Subject: MHI's Response to US-APWR DCD RAI No. 785-5885 Revision 3 (SRP 15.4.8)

MHI's Response to US-APWR DCD RAI No. 785-5885 Revision 3
(SRP 15.4.8)

RAI NO.: NO. 785-5885 REVISION 3
SRP SECTION: 15.04.08 - SPECTRUM OF ROD EJECTION ACCIDENTS (PWR)
APPLICATION SECTION: 15.04.08
DATE OF RAI ISSUE: 7/26/2011

QUESTION NO.: 15.04.08-11

Figure 15.4.8-2 Reactor Power versus Time
Rod Ejection (HFP, BOC)

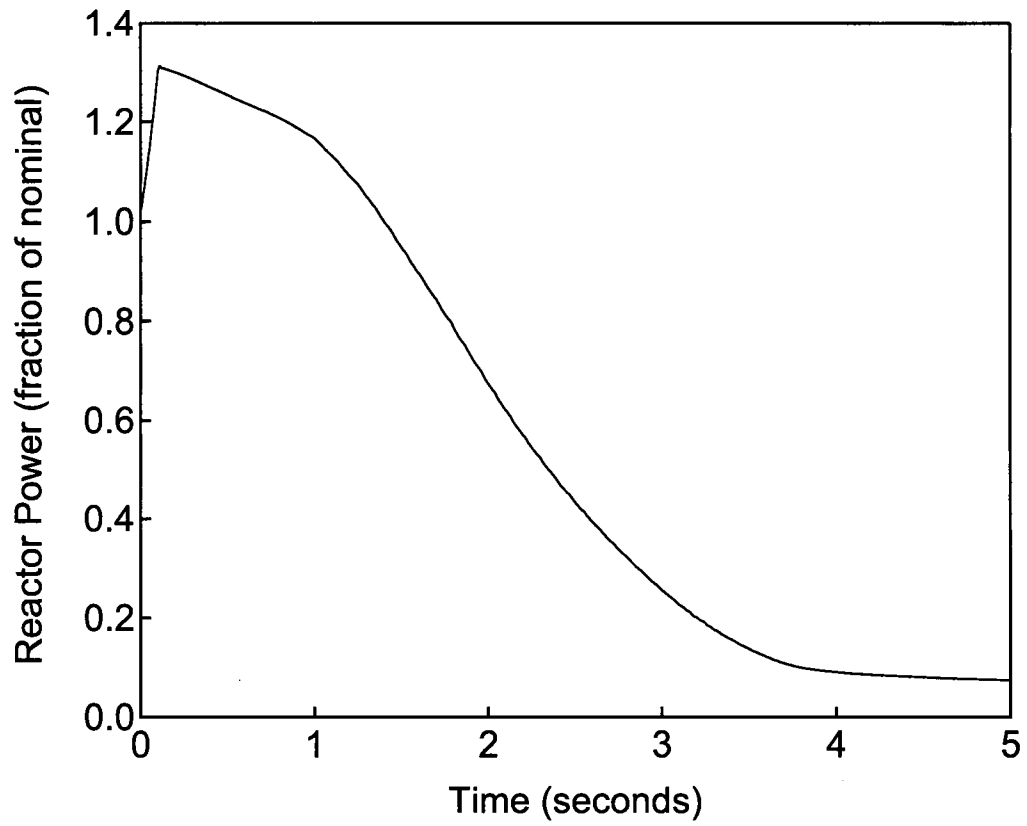
Analyses are performed for RCCA ejection at the BOC and EOC with HFP and HZP. For all cases, the RCCAs are inserted to their insertion limits before the rod ejection occurs. The reactor power, fuel and cladding temperature, and radial average fuel enthalpy transients for the HFP BOC case are presented in Figures 15.4.8-2 through 15.4.8-4. The same transient parameter information for the HFP EOC case is in Figures 15.4.8-5 and 15.4.8-7. The reactor power and fuel enthalpy transients for HZP cases are presented in Figures 15.4.8-8 through 15.4.8-10 for the BOC case and Figures 15.4.8-11 through 15.4.8-13 for the EOC case, respectively. The calculated sequence of events corresponding to these limiting events is provided in Table 15.4.8-1. These analytical results are discussed in the following paragraphs:

110 pcm and a design hot channel factor of 5.0 are assumed to provide margin for future cores. The reactivity insertion causes a rapid increase in power, and the power increase is terminated by Doppler feedback. The reactor trip is initiated by high power range neutron flux (high setpoint) and the reactor returns to subcritical following the trip. The peak fuel centerline temperature is ~~4220~~4232°F, which remains below the fuel melting temperature limit.
